RICHMOND COMMUNITY SCHOOL
Richmond High School: Mechanical Modernization Project
LWC Commission No. 20104.02

ADDENDUM #03
October 3, 2021

3 NATATORIUM SUPPLY DIFFUSER SECTION
SCALE: 1/4" = 1'-0"

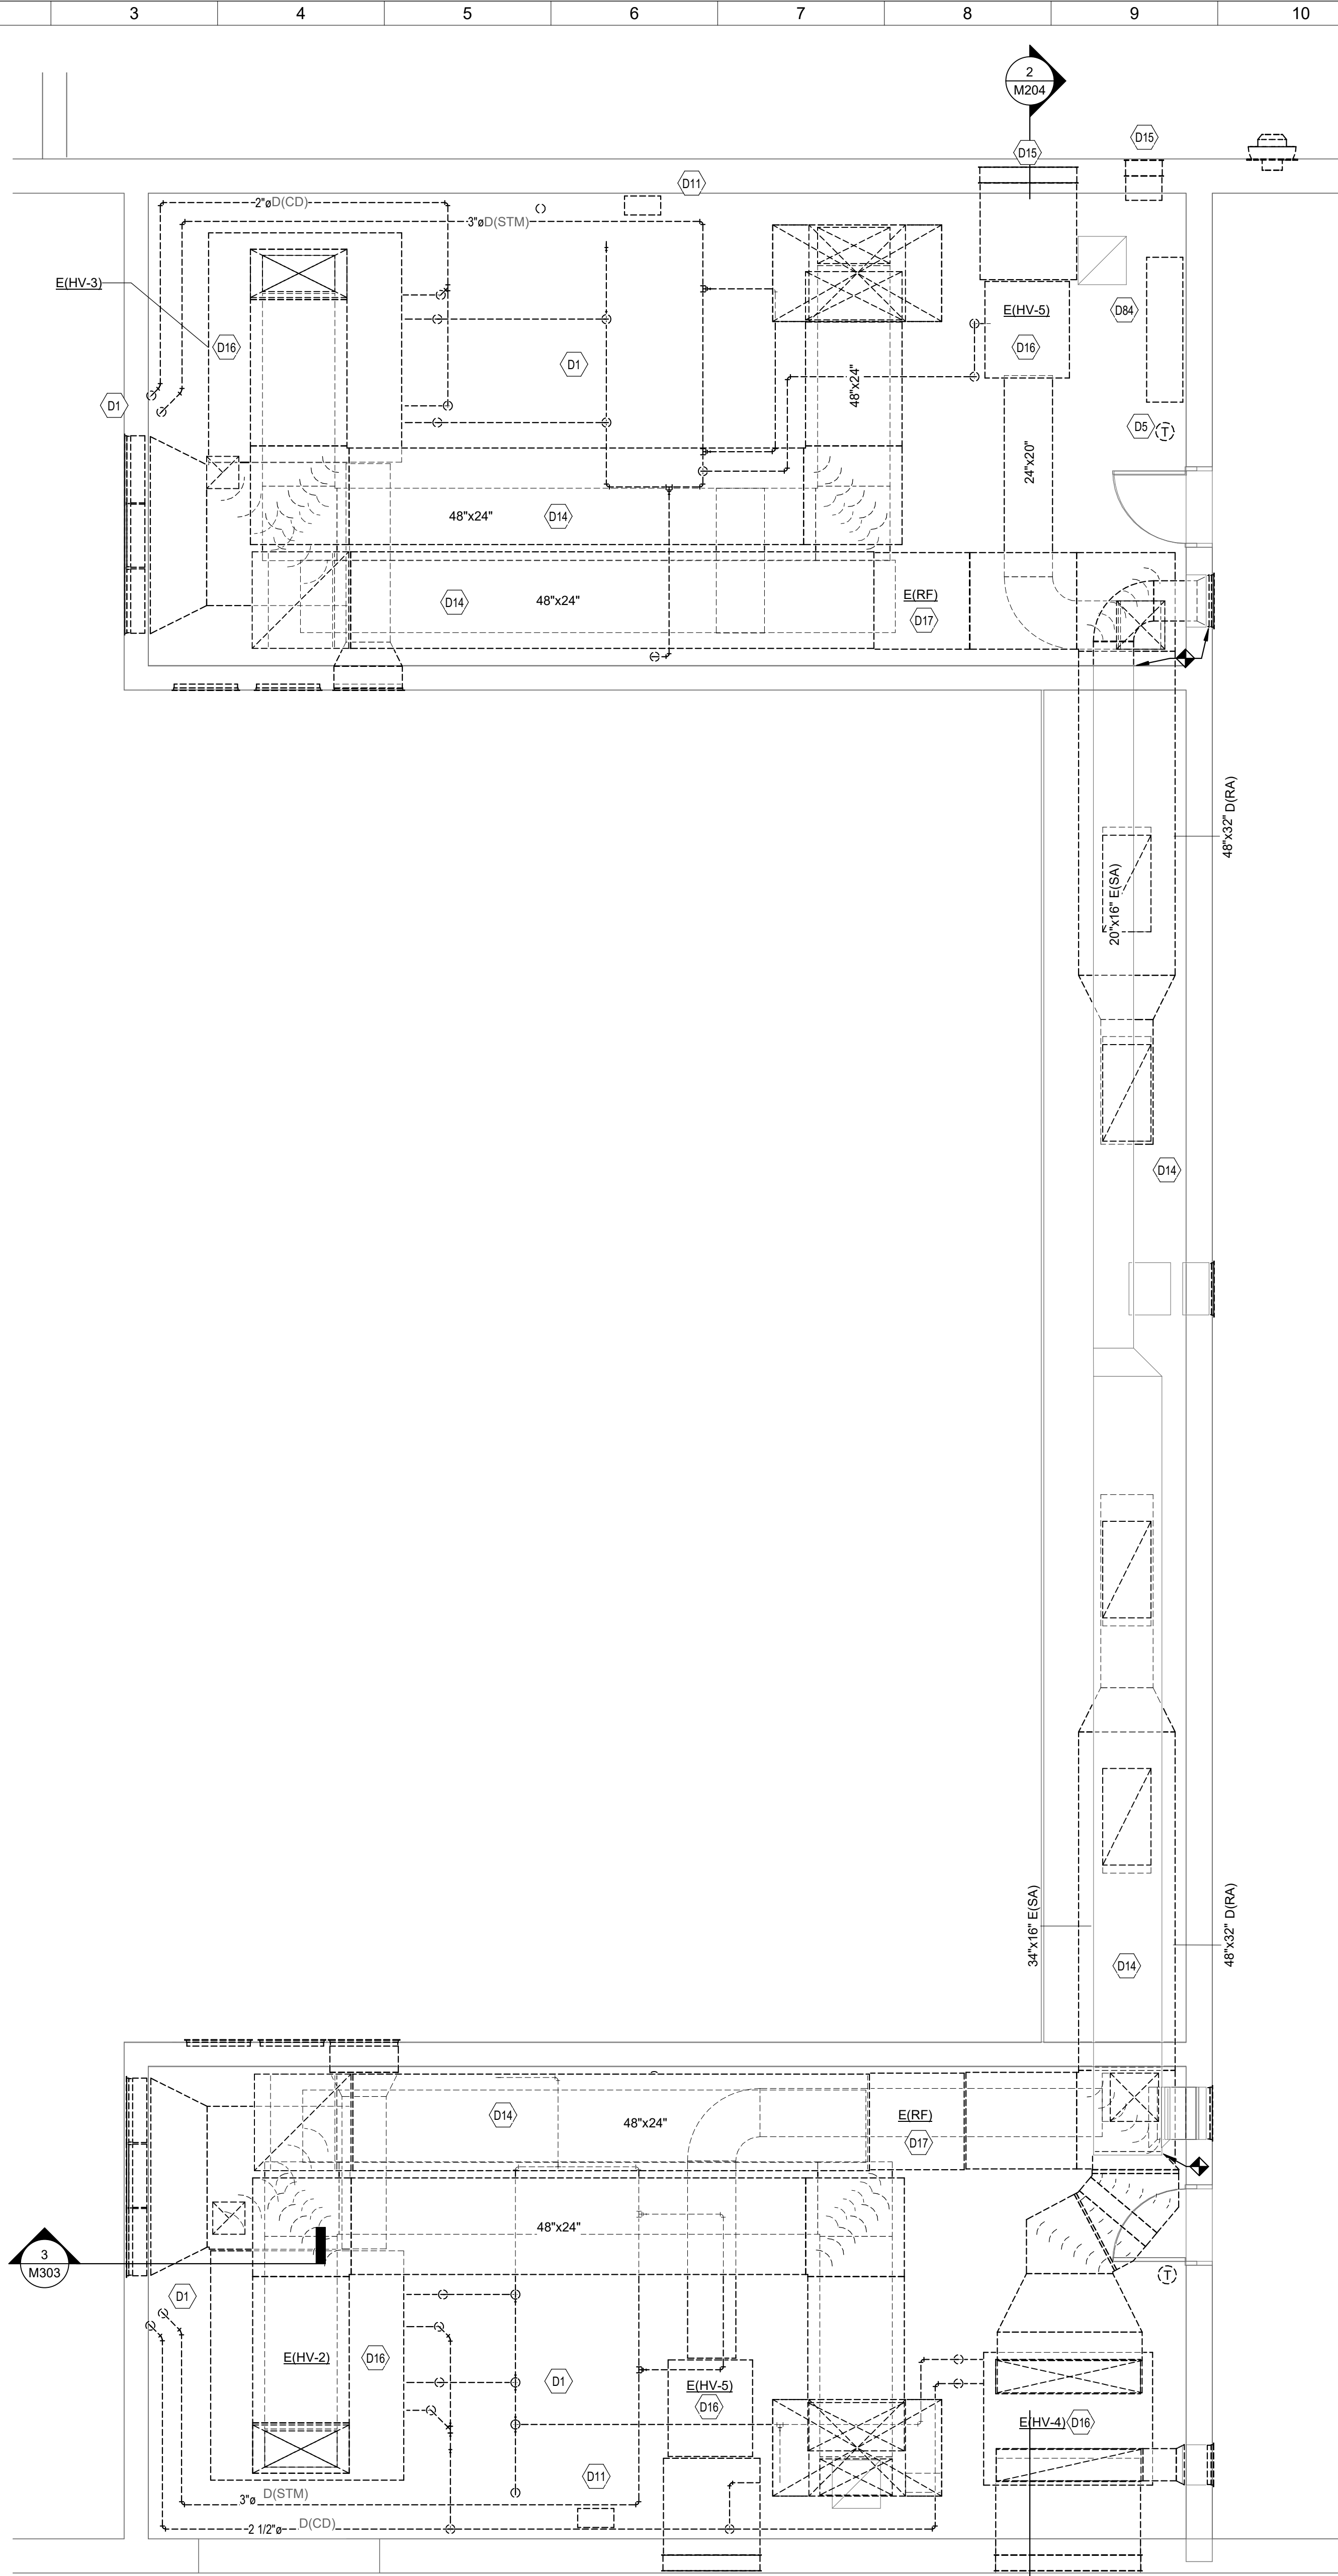
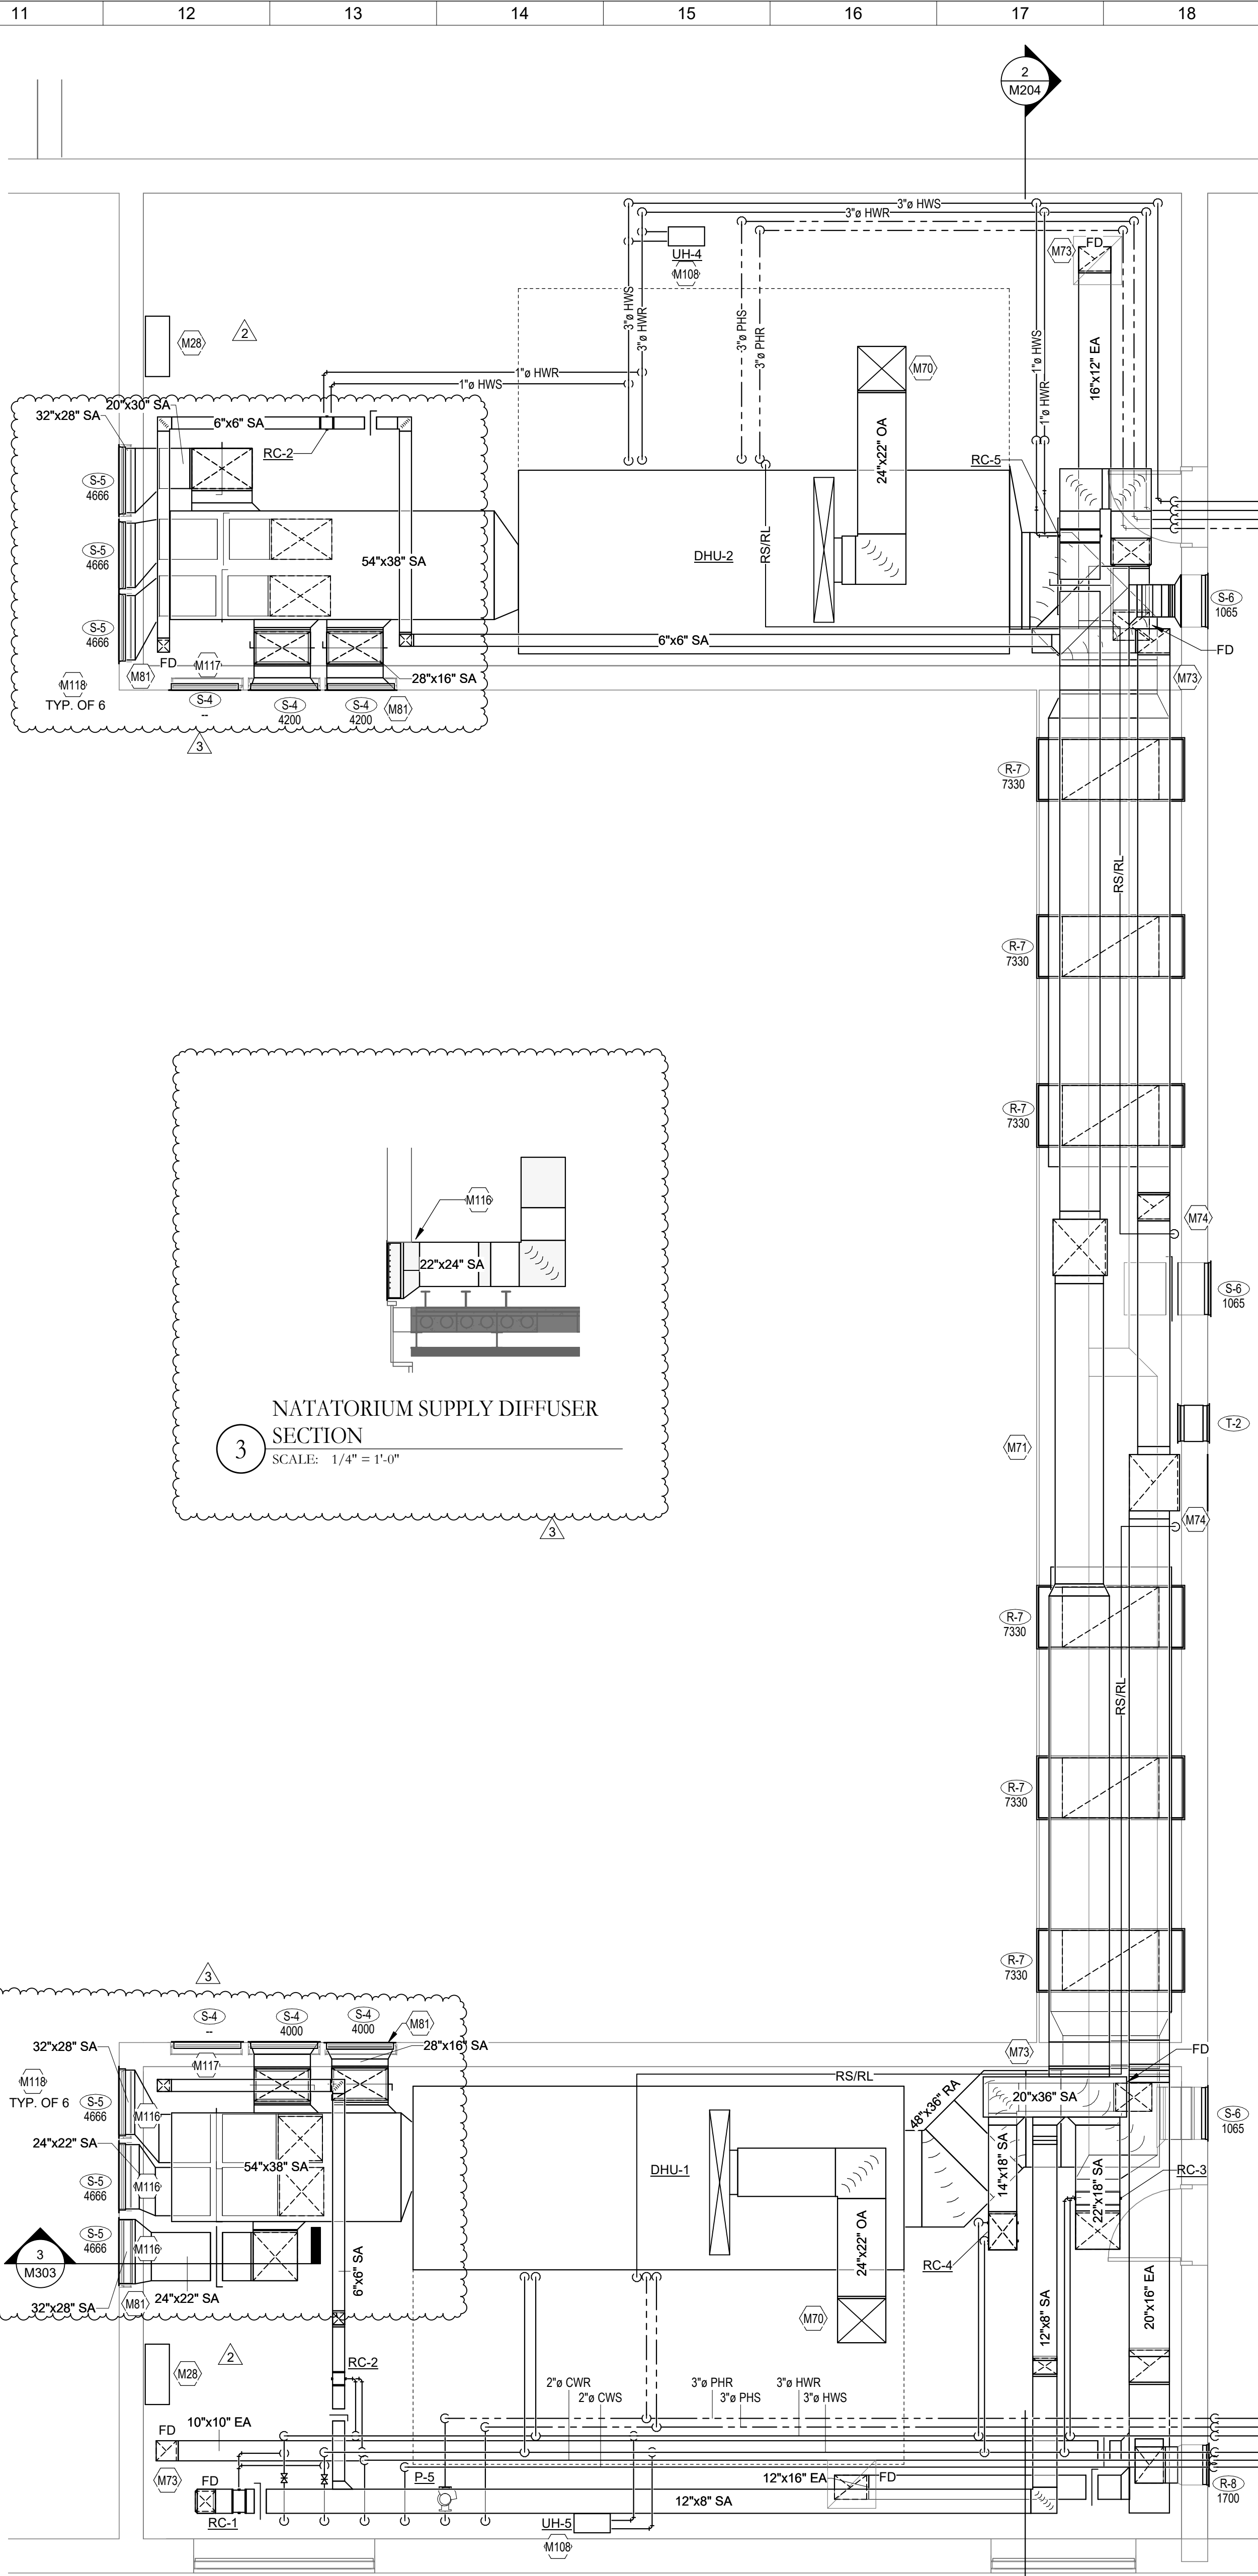
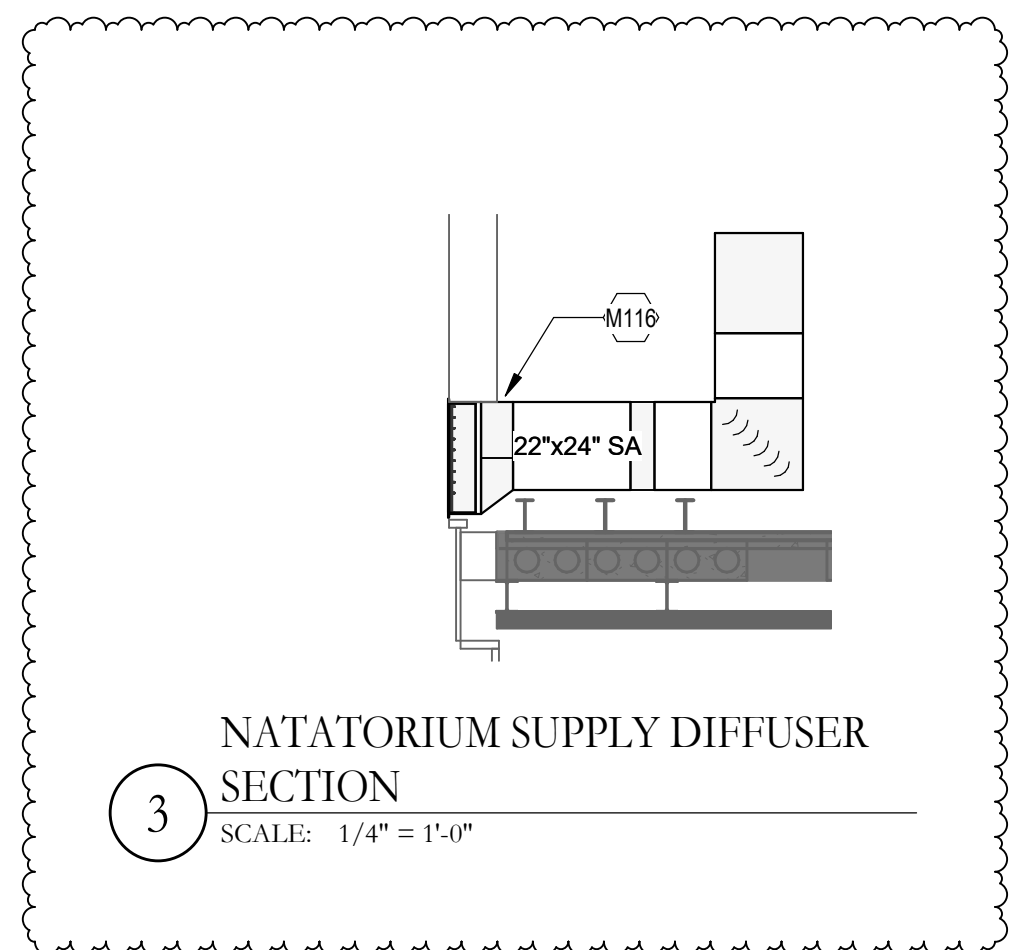
ITEM NO.3 Drawing M303

- A. Revisions to Natatorium supply diffusers.

Comm. No.	Date
20104.02	8.27.2021
Drawn	Drawing No.
JLK	M607
Checked	
NPR

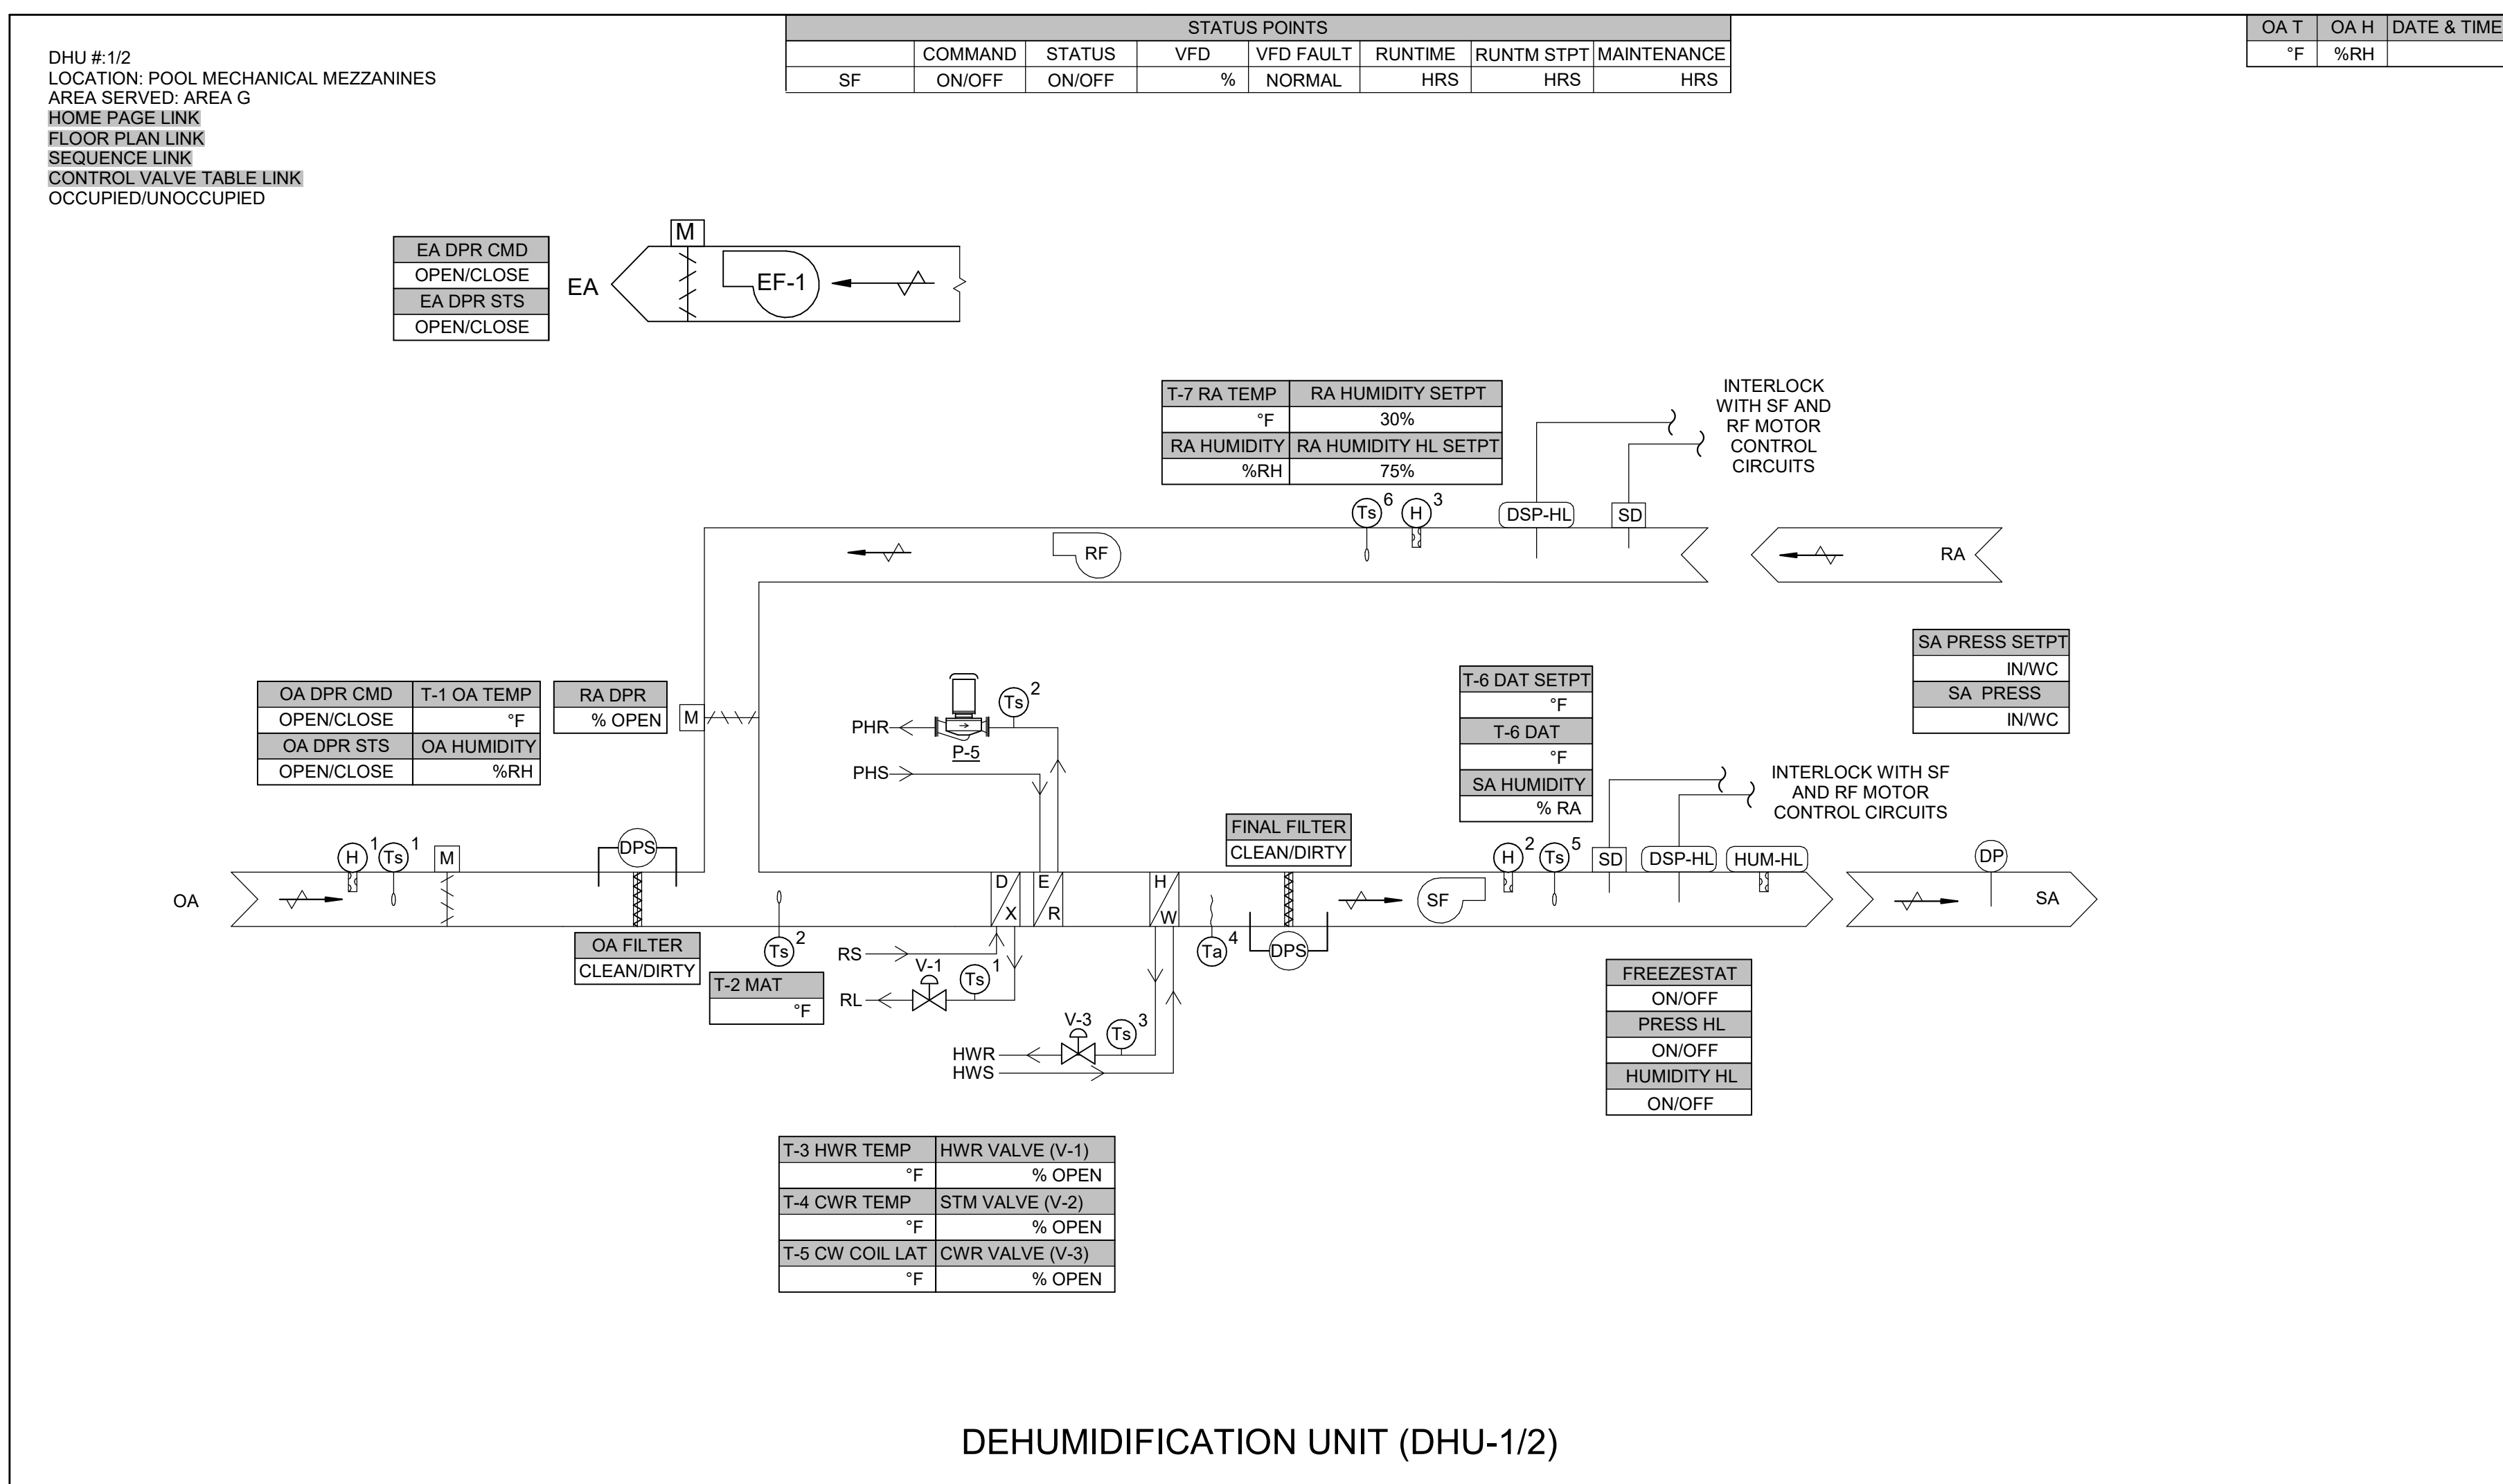
ITEM NO.4 Drawing M607

- A. Added HVLS control sequences
